HYDROLOGY K23/D18 Copperfield Apts. #2

COPPERFIELD APARTMENTS #2
DRAINAGE & GRADING PLAN
DECEMBER, 1982

AS BUILT CERTIFICATION
MARCH, 1984

SCALE 1" = 20'

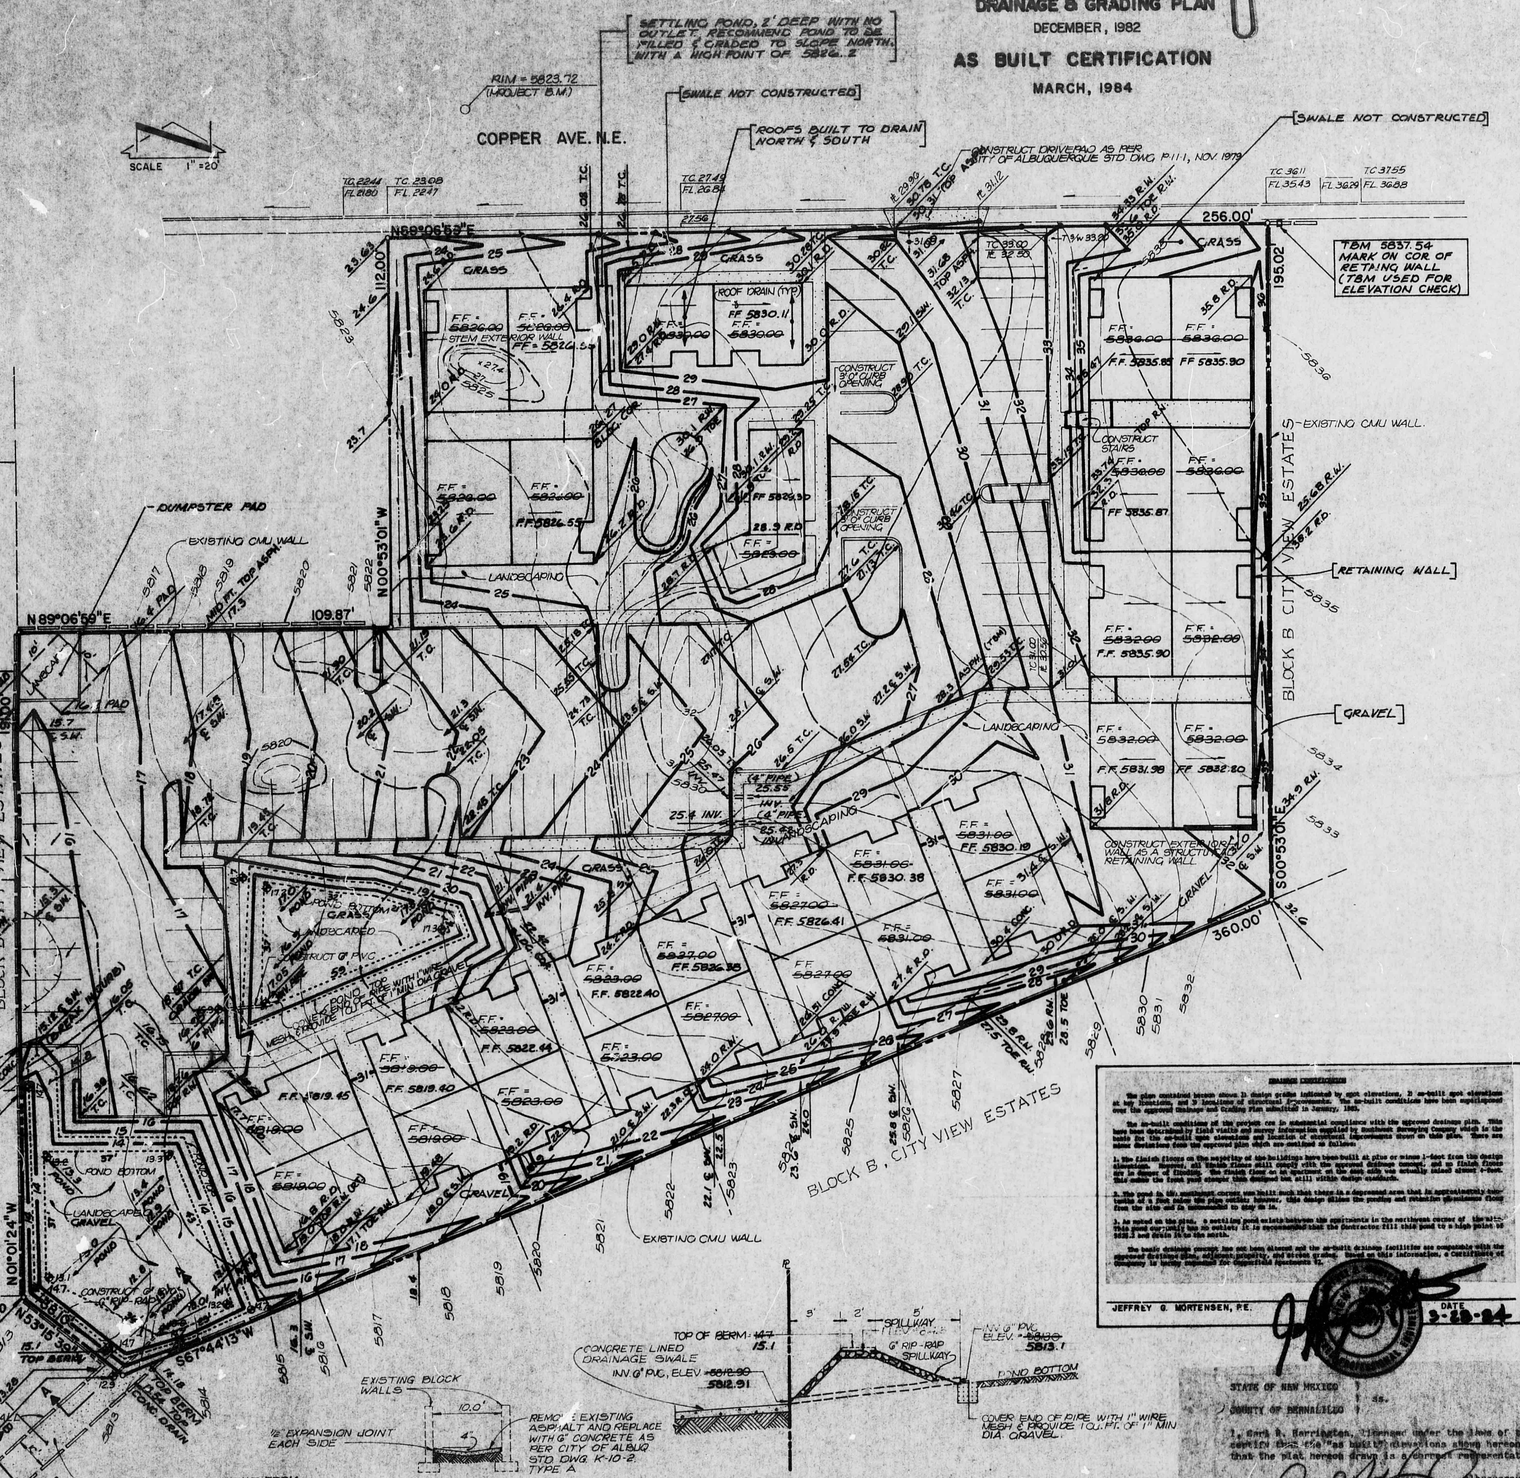
1. The finish floors on the majority of the buildings have been built at plus or minus 1-foot from the design elevations. However, all finish floors still comply with the approved drainage concept, and no finish floor is in danger of flooding. The finish floor on 30 apartments on the east side was actually raised approx 2-feet. This makes the lowest pad elevation this designed has still within design guards.

2. The pond in the southwest corner was built such that there is a depressed area that is approximately one-tenth of a foot below the pipe outlet however, this design allows the ponding and retention phenomenon flow from the site and is recommended to stay as is.

3. As noted on the plan, a settling pond exists between the apartments in the northeast corner of the site. This pond currently has no outlet. It is recommended that the contractor fill this pond to a high point of 5826.2 and drain it to the north.
